# Sea Center CF- ADA Evaluation

**CF-Lake Jackson TX, Sea Center ADA Evaluation**

**Accessibility Evaluation**

**Inspection Date: 07/28/2021**

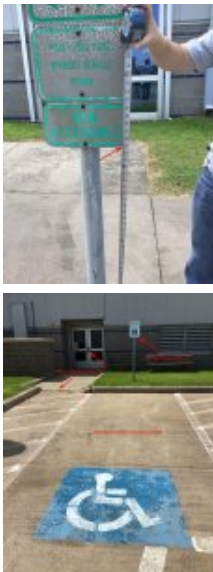
Finding Number	Area Description	Finding	As Built	Recommendation	Citation	Photos	Figure																										
1	Exterior of Property (Public): Visitors Center Parking Lot (6 Spaces) 1 Van 5 Car	The parking lot has been found to be in substantial compliance with accessibility codes, standards, and regulations. Needs Photo representation.	Parking lot meets majority compliance standards, Parking lot considered compliant. There are 6 accessible spots in front of building (1 Van 5 Car) and ? access aisles. Needs photo representation	N/A	2012 TAS Section: Advisory 2010 ADAS Section: Advisory 2015 ABAAS Section: Advisory																												
2	Exterior of Property (Public): Visitors Center Parking Lot (6 Spaces) 1 Van 5 Car	The required number of van accessible stalls is not provided. There are (XX) accessible parking stalls including (XX) designated for a van. There should be a minimum of (XX) accessible parking stalls including a minimum of (XX) van accessible stalls.	Due to parking lot size an additional van stall needs to be added. There are 6 accessible spots in front of building. Far (L) accessible stall meets van stall dimensions and markings requirements. Pending photo representation,	Recommend adding additional van stall identified on far (L) side of parking lot. <a href="https://www.access-board.gov/ada/#ada-208_2">https://www.access-board.gov/ada/#ada-208_2</a> <a href="https://www.access-board.gov/ada/#ada-208_2_4">https://www.access-board.gov/ada/#ada-208_2_4</a>	2012 TAS Section: 208.2, 208.2.4  2010 ADAS Section: 208.2, 208.2.4  2015 ABAAS Section: F208.2, F208.2.4

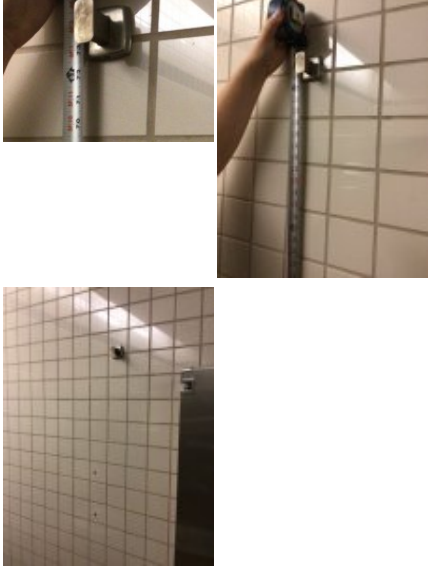
16	Exterior of Property (Public): Hatchery Building Parking Lot (3 Spaces) 1 Van 2 Car - Pathway to Building (Parking Lot to Main Entrance)	The surface of the curb ramp is not firm, stable and/or slip resistant.. Floor and ground surfaces shall be stable, firm, and slip resistant.	From van parking space to main entrance. Curb ramp is in need of repair, crumbling and deteriorating. Side flares need to be checked for compliance.	<a href="https://www.access-board.gov/ada/#ada-302_1">https://www.access-board.gov/ada/#ada-302_1</a>	2012 TAS Section: 302.1  2010 ADAS Section: 302.1  2015 ABAAS Section: 302.1

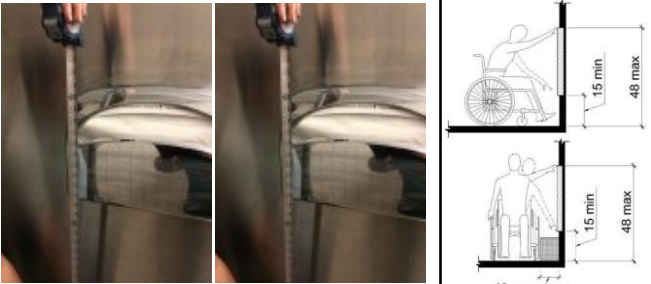
Finding Number	Area Description	Finding	As Built	Recommendation	Citation	Photos	Figure
17	Exterior of Property (Public): Hatchery Building Parking Lot (3 Spaces) 1 Van 2 Car - Pathway to Building (Parking Lot to Volunteer Side Entrance)	The accessible route contains loose gravel and/or surface materials that do not provide for a stable, firm slip resistant surface. Floor and ground surfaces shall be stable, firm, and slip resistant.	From car accessible space to volunteer side entrance. Overgrowth prevent access, large gaps in walkway.	<a href="https://www.access-board.gov/ada/#ada-302_1">https://www.access-board.gov/ada/#ada-302_1</a>	2012 TAS Section: 302.1  2010 ADAS Section: 302.1  2015 ABAAS Section: 302.1		
18	Exterior of Property (Public): Pathway to Holding Ponds - TOUR	State and local governments have an obligation to make their programs and services accessible to persons with disabilities. This may or may not require the alteration, addition or construction of existing facilities which predate The Americans with Disabilities Act (ADA) of 1990. Under the Code of Federal Regulations Section 35.151(b)(2) State and Local Government Title II entities may provide programmatic access where alterations to existing facilities would result in undue financial and administrative burdens. For Example, A public entity has six courtrooms in two existing buildings and determines that only three of those courtrooms and the public use and common use areas serving those courtrooms in one building are needed to be made accessible in order to satisfy its program access obligations. The entity must comply with 2010 Standards unless compliance would result in undue financial and administrative burdens and must take other actions that would not result in an undue financial burden to ensure access to persons with disabilities. This may include the scheduling of the various types of cases, hearings etc. in accessible courtrooms and relocating them where necessary to accommodate persons with disabilities. Having a defined program and effective communication process in place to ensure the public and employees can request accommodations is necessary to ensure equal access to the county's court system. Program access is not part of this evaluation and this information is being provided as an advisory only.	Element can be accessed as majority of exterior route in good working condition. This element is considered accessible. Pending photo verification	Upgrade areas of deterioration to meet full compliance.	2010 ADAS Section: Advisory

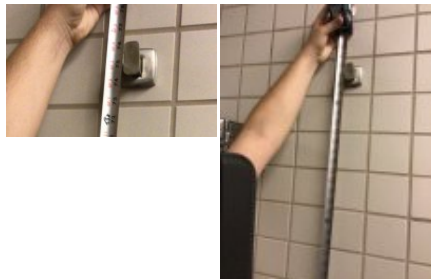
21	Structures on Property (Public) - Tour/Public Componets : Visitors Center (Interior) - Restroom (Men's)	The Men's restroom has been found to be in substantial compliance with accessibility codes, standards, and regulations.	The restroom meets compliance and is current with ADA standards. Need photo representation of restroom and its elements,	N/A	2012 TAS Section: Advisory  2010 ADAS Section: Advisory  2015 ABAAS Section: Advisory

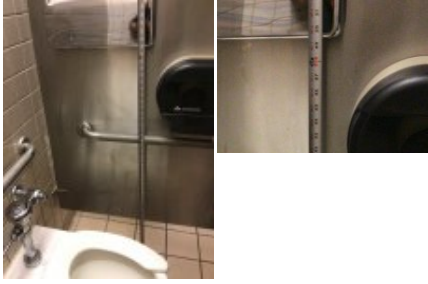
Finding Number	Area Description	Finding	As Built	Recommendation	Citation	Photos	Figure
22	Structures on Property (Public) - Tour/Public Componets : Visitors Center (Interior) - Restroom (Men's)	The water closet compartment is missing a loop handle on the one side of the door. Water closet compartments must be equipped with a door that has a loop or U-shaped handle on both sides of the door near the latch. The latch must be flip-over style, sliding or other hardware not requiring the user to grasp or twist.	Loop handle installed. Pending photo of update/correction	Install a loop handle on pull side of door within compliant range. <a href="https://www.access-board.gov/ada/#ada-604_8_1_2">https://www.access-board.gov/ada/#ada-604_8_1_2</a>	2012 TAS Section: 604.8.1.2  2010 ADAS Section: 604.8.1.2  2015 ABAAS Section: 604.8.1.2		
23	Structures on Property (Public) - Tour/Public Componets : Visitors Center (Interior) - Restroom (Men's)	The coat hook is installed greater than 48 inches above the finished floor. Where a forward reach is unobstructed, the high forward reach shall be 48 inches maximum above the finished floor.	Coat hook installed out of range over 72" Pending photo of update/correction	Move coat hook into compliant range of front approach or side approach. <a href="https://www.access-board.gov/ada/#ada-308_2_1">https://www.access-board.gov/ada/#ada-308_2_1</a>	2012 TAS Section: 308.2.1  2010 ADAS Section: 308.2.1  2015 ABAAS Section: 308.2.1

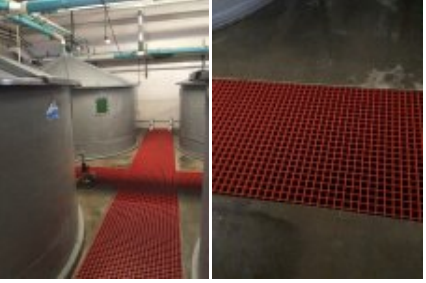
Finding Number	Area Description	Finding	As Built	Recommendation	Citation	Photos	Figure
33	Structures on Property (Public) - Tour/Public Componets : Visitors Center (Interior) - Conference Room - TOUR	The conference room has been found to be in substantial compliance with accessibility codes, standards, and regulations.	The conference room is spacious, clutter free, and accessible. Also serves as tour gathering area. Pending photo verification.	N/A	2012 TAS Section: Advisory  2010 ADAS Section: Advisory  2015 ABAAS Section: Advisory		
34	Structures on Property (Public) - Tour/Public Componets : Hatchery Building (Interior) - TOUR	The interior hallways has been found to be in substantial compliance with accessibility codes, standards, and regulations.	Interior hallway is within compliance. Need photo verification	N/A	2012 TAS Section: Advisory  2010 ADAS Section: Advisory  2015 ABAAS Section: Advisory

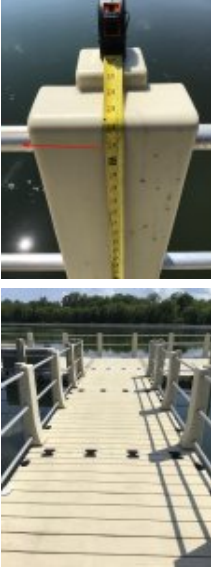
Finding Number	Area Description	Finding	As Built	Recommendation	Citation	Photos	Figure
42	Outdoor Features (Public) : Wetlands Trail	Boardwalk elements include, Guardrail height , Edge protection, Running and Cross Slope, boardwalk surfacing. Guardrails should remain clear of overgrowth and useable.	Boardwalk path of travel and guard railing components need to be evaluated. Pending evaluation	N/A - Refer to Finding	2012 TAS Section: Recommended 2010 ADAS Section: Recommended 2015 ABAAS Section: Recommended		
43	Outdoor Features (Public) : Wetlands Trail - Wetland Trail Ramp	Ramp elements include, Guardrail height (verified) , Edge protection, Running and Cross Slope, Ramp surfacing	Ramp components need to be evaluated Pending evaluation	N/A - Refer to Finding	2012 TAS Section: Recommended 2010 ADAS Section: Recommended 2015 ABAAS Section: Recommended		
44	Outdoor Features (Public) : Wetlands Trail - Wetland Trail Ramp	The ramp does not have compliant handrails. Handrails are required on both sides of all surfaces that are sloped greater than 5 percent (1:20). Handrails must be between 34 inches and 38 inches above the ramp surface, and must extend horizontally 12 inches beyond the top and bottom of the ramp. The diameter of the handrails must be 1 1/4 inches minimum and 2 inches maximum in cross-sectional nominal dimension for circular handrails. Handrail gripping surfaces with a non-circular cross section shall have a perimeter dimension of 4 inches minimum and 6 1/4 inches maximum, and a cross-section dimension of 2 1/4 inches maximum. The space between handrails and walls must be 1-1/2 inches minimum.	Handrails do not meet compliance in style, mounting location, missing extensions.	Handrails type, style, and installation are not compliant. Review handrail components to make accessible <a href="https://www.access-board.gov/aba/#aba-505_1">https://www.access-board.gov/aba/#aba-505_1</a>	2012 TAS Section: 505.1 2010 ADAS Section: 505.1 2015 ABAAS Section: 505.1
